Metropolitan Historic Zoning Commission
Sunnyside in Sevier Park
3000 Granny White Pike
Nashville, Tennessee 37204
Telephone: (615) 862-7970
Fax: (615) 862-7974

STAFF RECOMMENDATION
2804 Hawthorne Place
April 18, 2018

Application: New construction - addition
District: Belmont-Hillsboro Neighborhood Conservation Zoning Overlay
Council District: 18
Map and Parcel Number: 11704022500
Applicant: Josh and Susan Tyler, Owners
Project Lead: Sean Alexander, sean.alexander@nashville.gov

2804 Hawthorne Place, front.

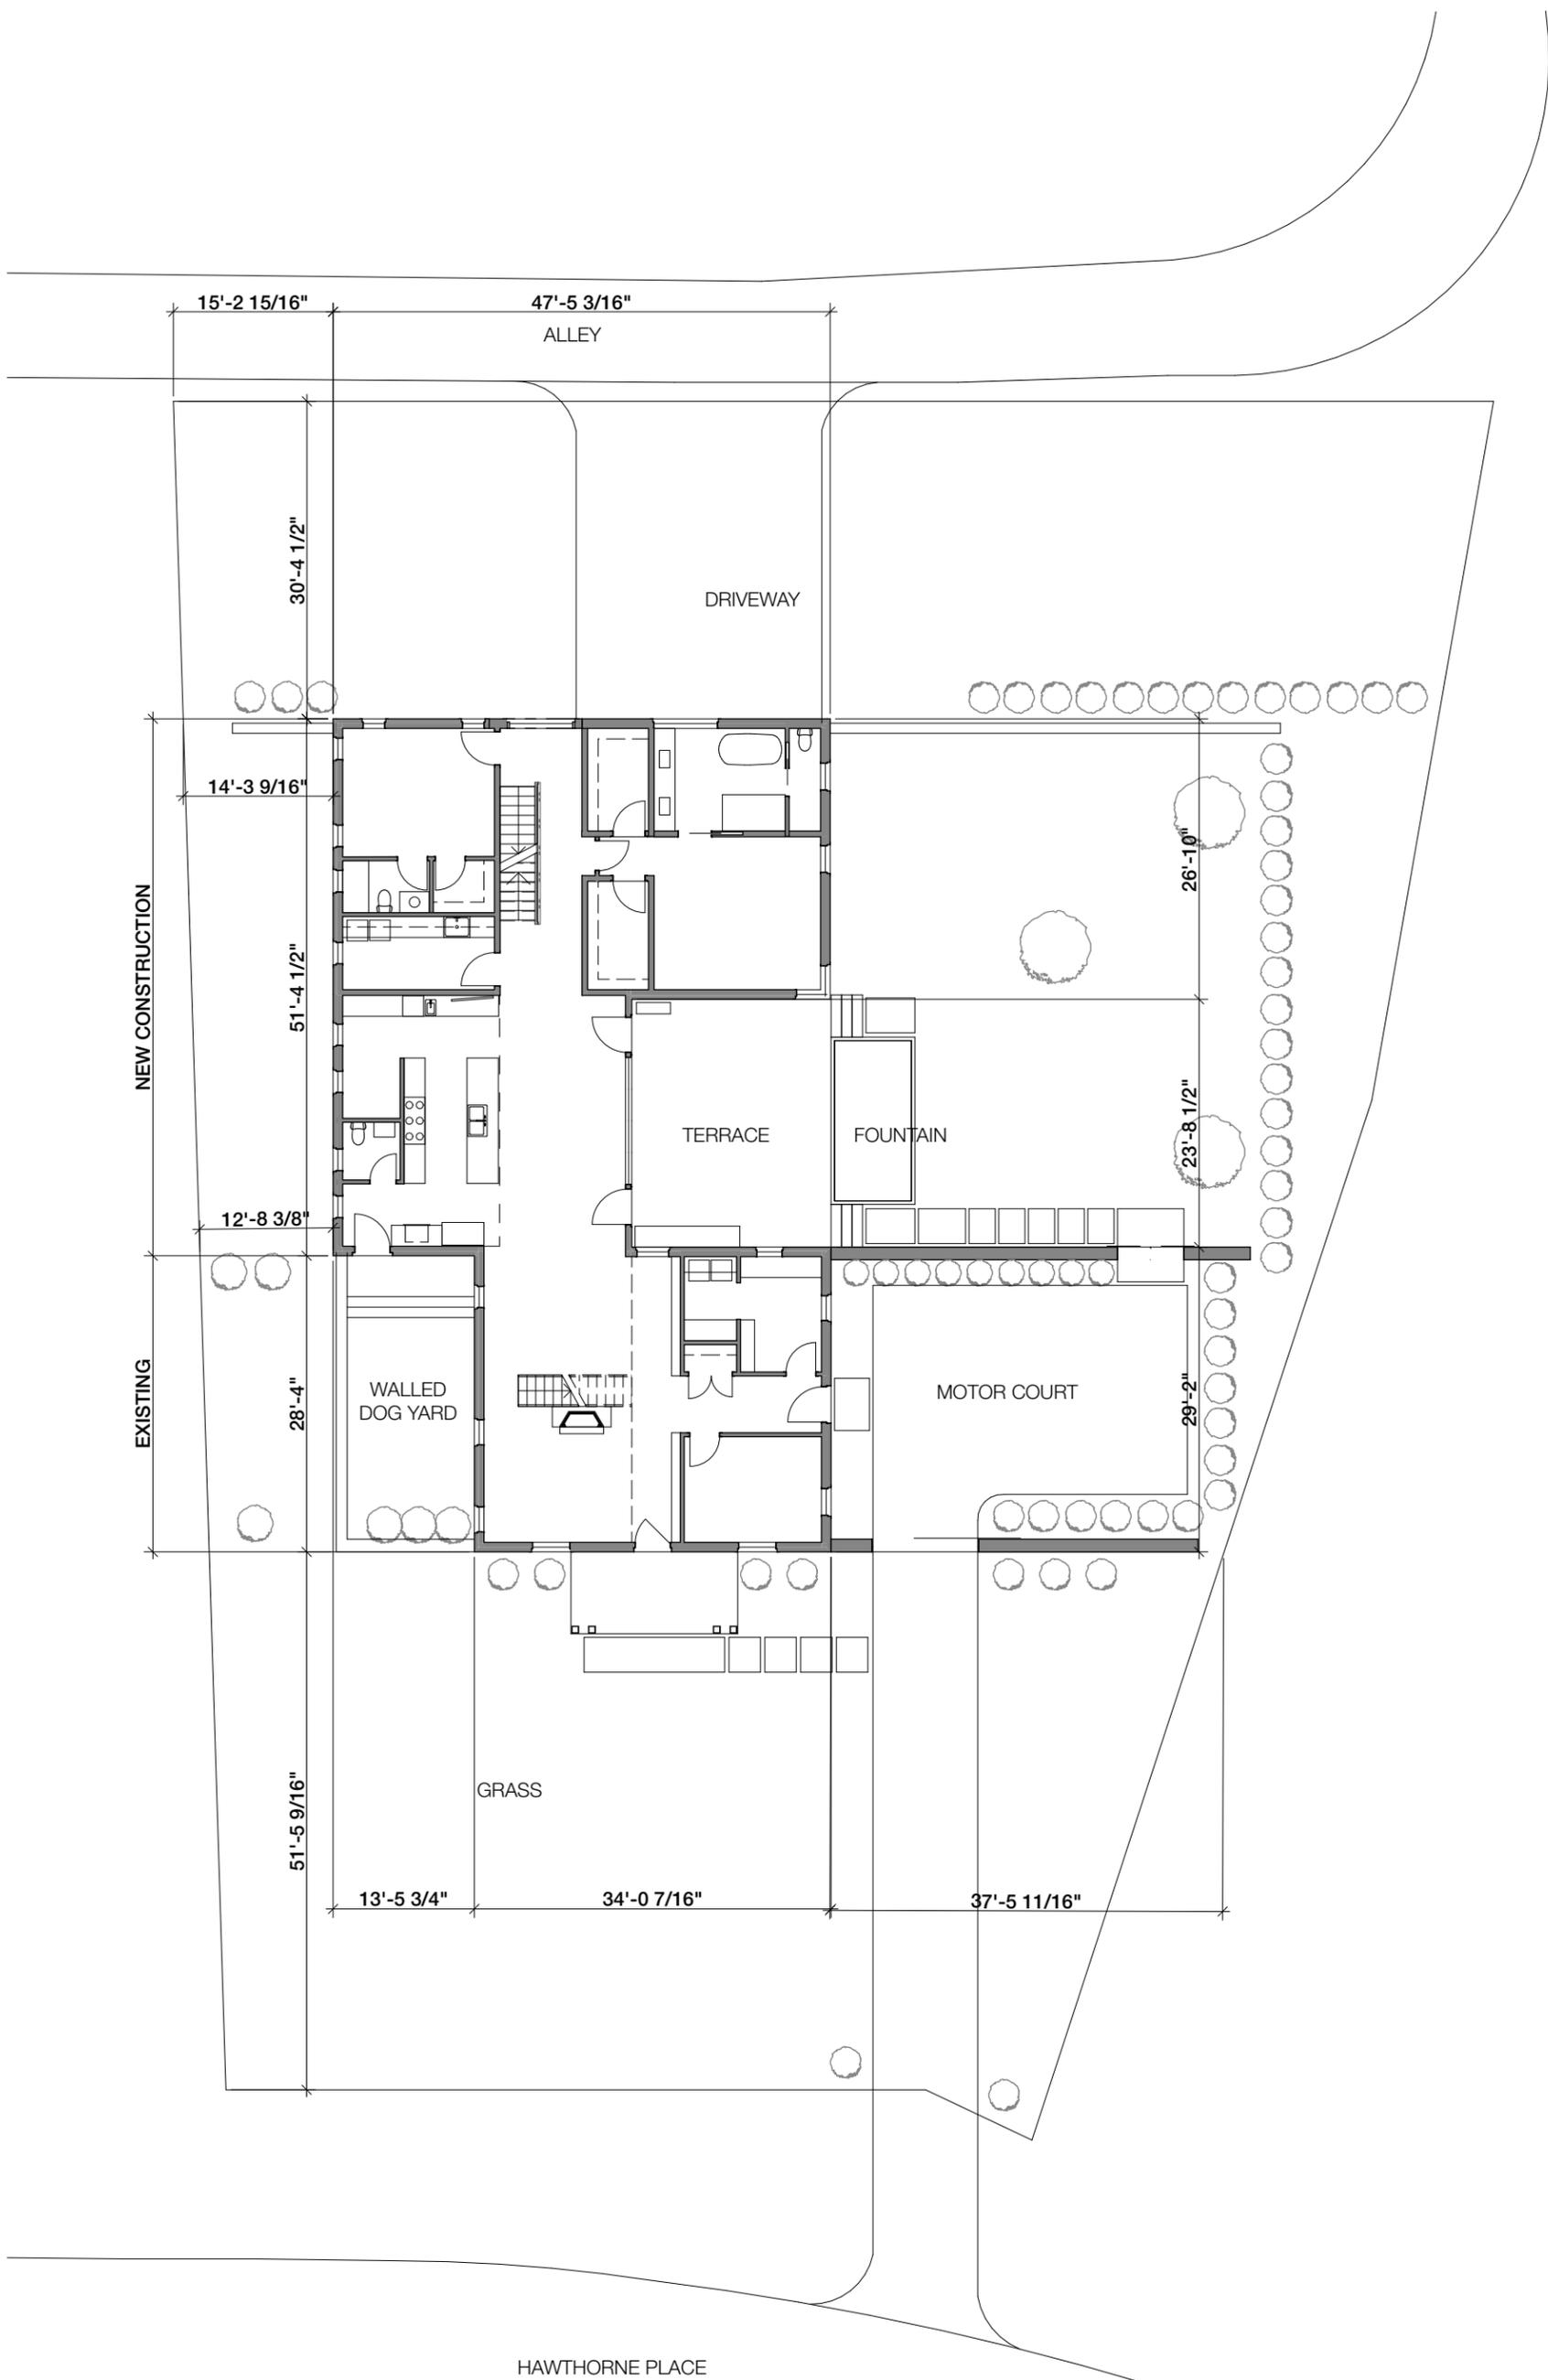
Background: The structure at 2804 Hawthorne Place is a one story Minimal Traditional house, constructed between 1939 and 1944. The building is a one-story brick veneered house with a side-gabled roof, shallow eaves and a gabled projecting front porch that was likely added after 1957. The house is considered to be contributing to the historic character of the surrounding area.

Site Plan

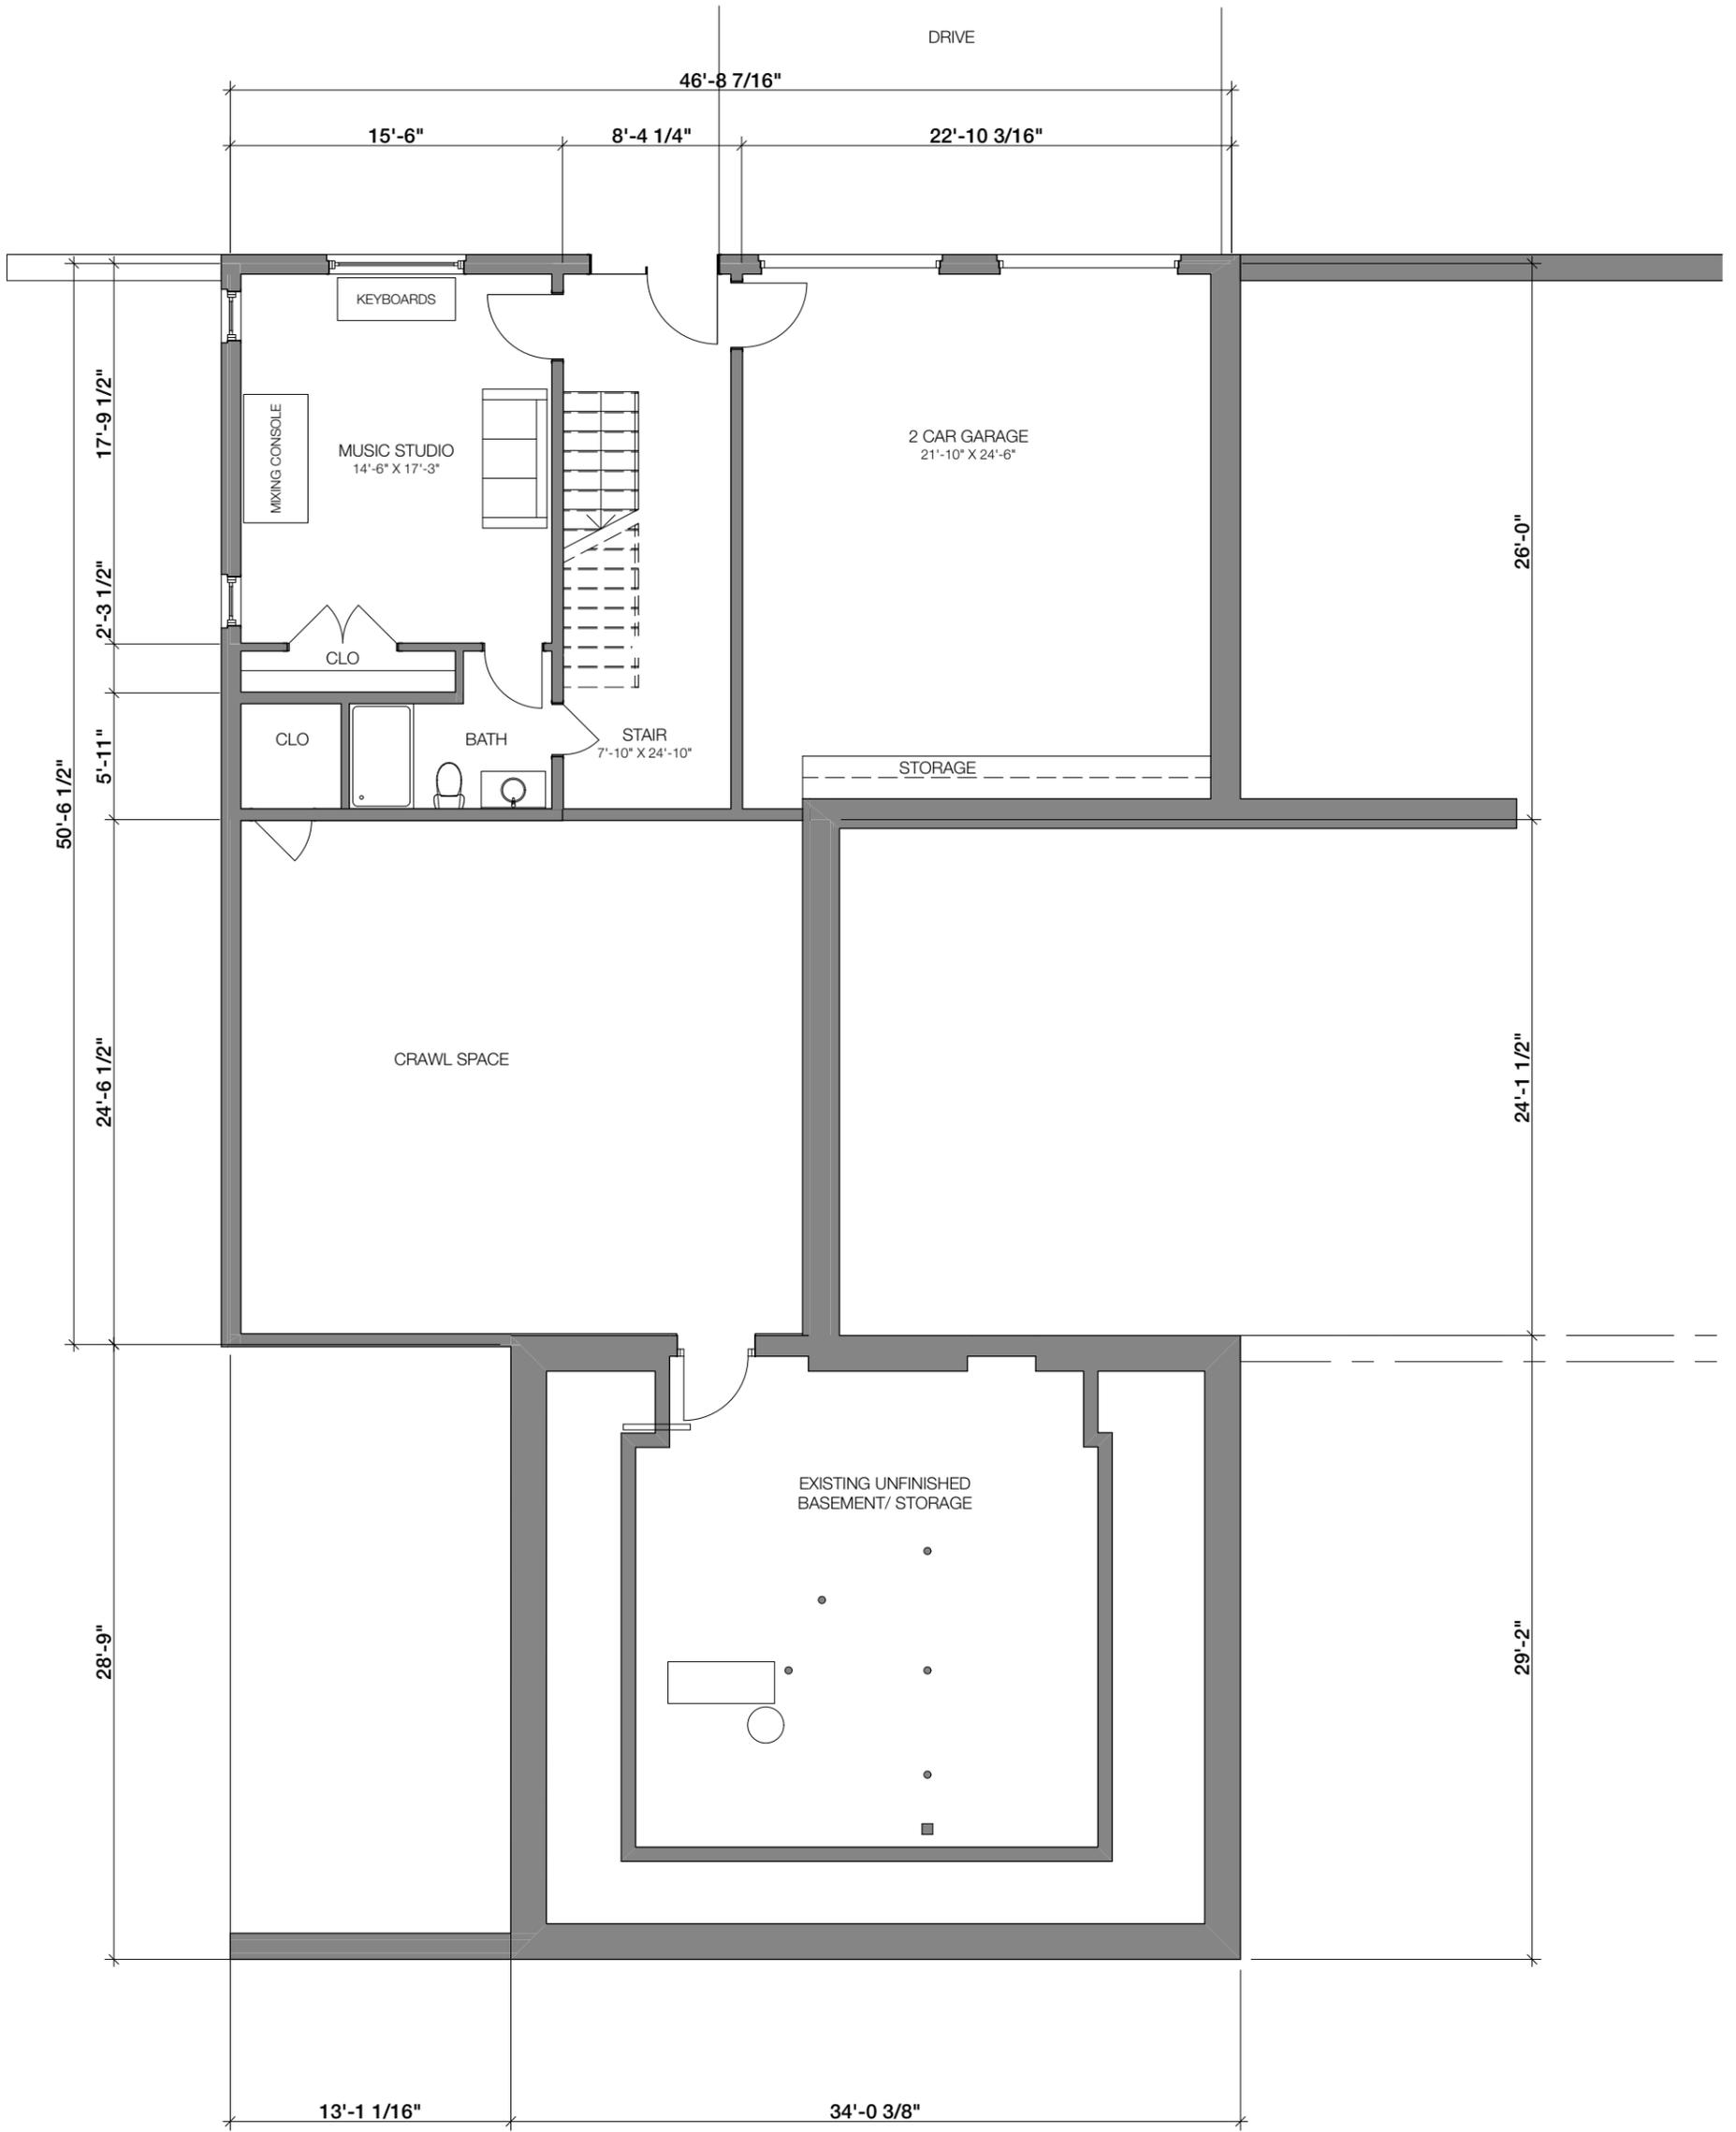
Location & Removability: The proposed addition will be at the rear of the building. On the right side the addition will be stepped in nineteen feet (19') from the side of the house. The left side will tie into the rear-left corner and extend out thirteen feet (13') to the left of the existing house's silhouette. Additions should typically be stepped in from the sides of a house on both sides. Even when an addition is going to be wider than the historic house, and inset or alcove that goes back before going wider would help to preserve the original form and minimize its impact.

Appurtenances & Utilities: The proposal indicates that the existing driveway on the left side of the house will be removed, with a new driveway installed on the right side of the house terminating inside a walled motorcourt. The plans also depict a “walled dog yard” will to be built on the left side of the house. There are no similar walled yard areas or side-yard parking areas associated with any historic houses in the neighborhood. The HVAC units are currently to the left side of the house where the walled dog yard would be constructed, but their new location is not indicated. Staff finds that the walls associated with the project are not compatible with the historic building and that the project does not meet Section II.B.1.h of the design guidelines.

① **Front Elevation**
 SCALE: 1/8" = 1'-0"
 0 4' 8' 16'

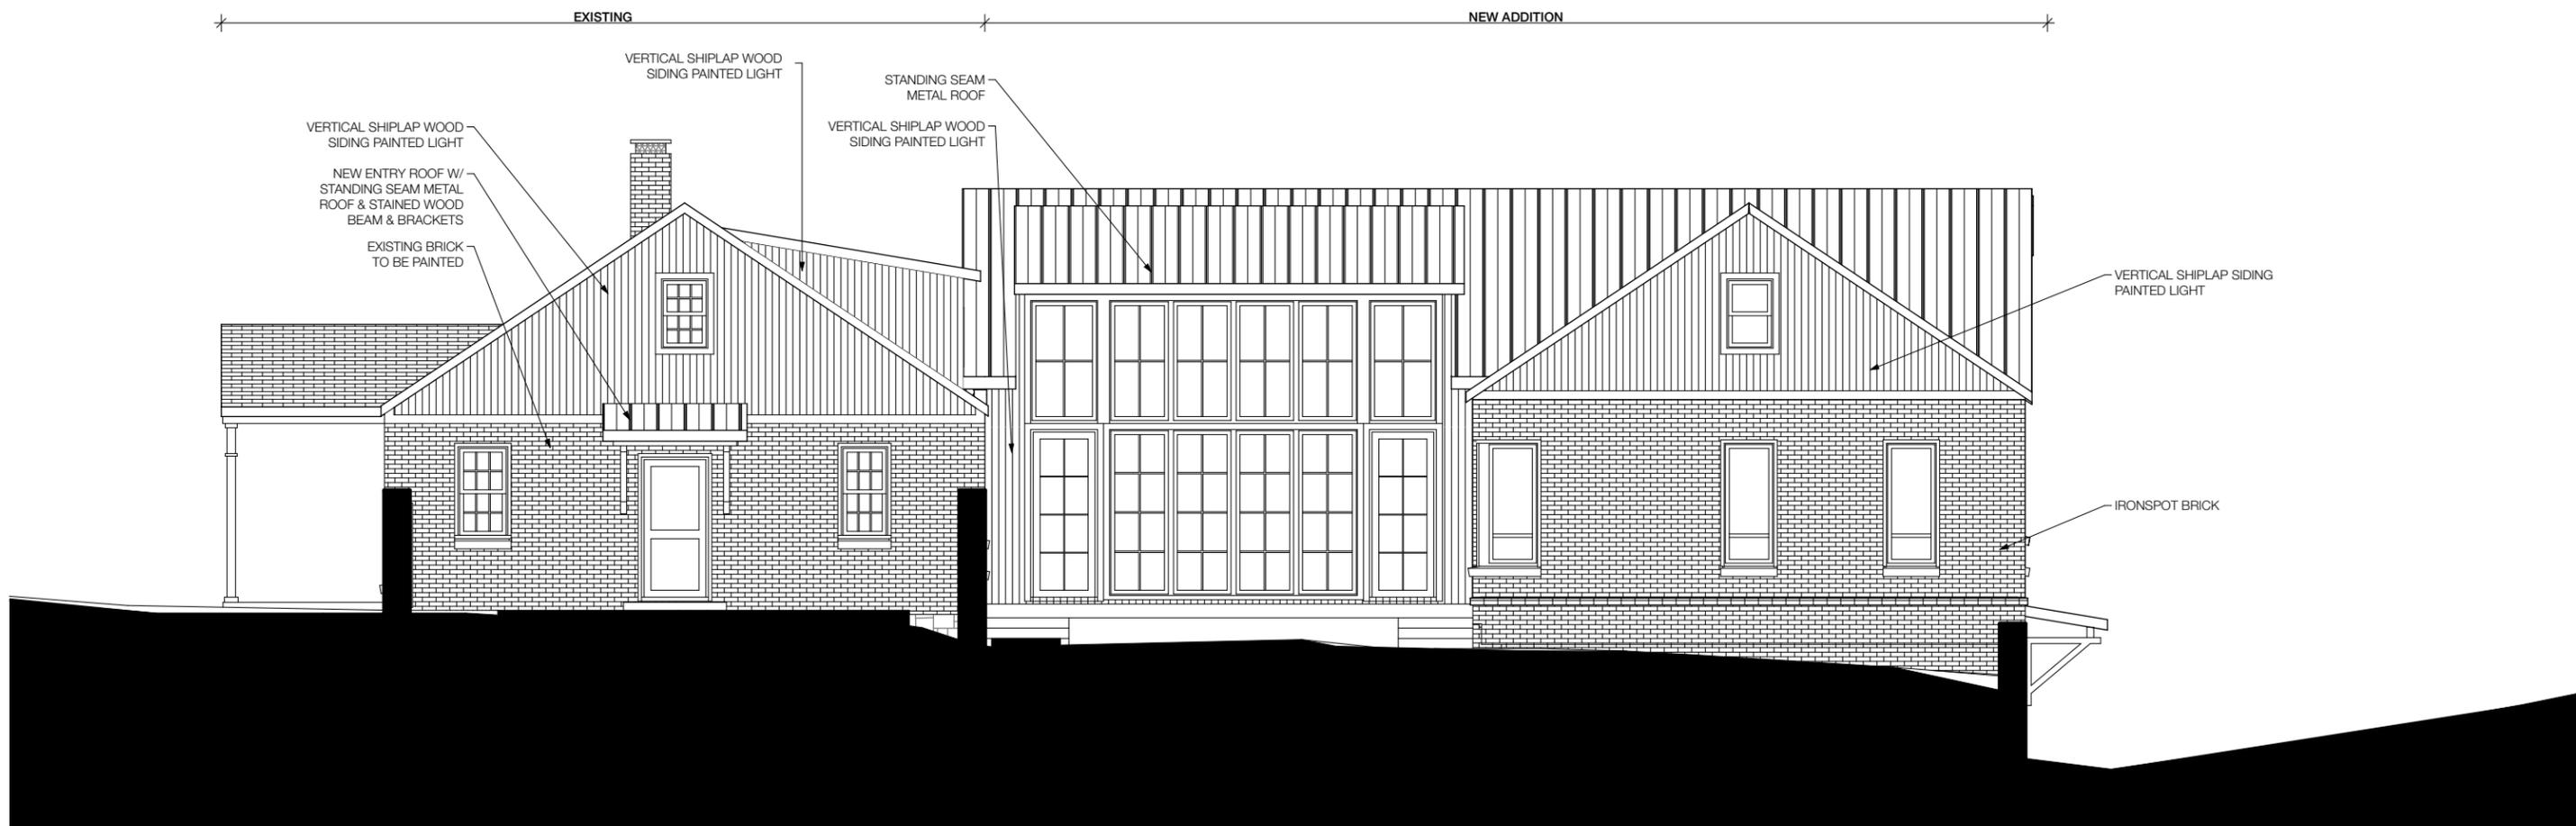
The proposal also involves altering a pair of windows on the front façade of the building. These windows are currently above a frame and panel half-wall, a condition that may be original. The half wall and windows would be removed and larger windows installed in their places. Staff finds that altering the proportions of the original front façade window openings constitutes partial demolition, which is not appropriate under Section V.B.1 of the design guidelines for inappropriate demolition.

Height & Scale: The addition is intended to look like a one and one-half story gable with a kneewall, shed dormer, and a material change between floors, but because the dormer runs the entire length of the façade and does not step in from the wall below it is effectively a full second story. The primary roof of the addition will be a gable, perpendicular to the original roof ridge and eight inches (8") higher. The knee-wall eave would be three feet (3') higher than the eaves of the house and the wall-dormer's eaves would be eight feet (8') higher. Staff finds that the heights and two story form of the proposed addition will be highly visible and contrast greatly with the one story historic house.

Roof form: The roof of the addition would have a section of eave with a 6:12 pitch facing the front, but the pitch over the second story portion of the addition will be 2:12.

As described in the Height section above, this wall dormer runs the entire length of the façade and is not set back from the first story, effectively becoming a full story. The interior sections of roof will match the 8:12 pitch of the original roof. Staff finds that the low slope of the second story is not compatible with the historic house and that the project does not meet Section II.B.1.e of the design guidelines.
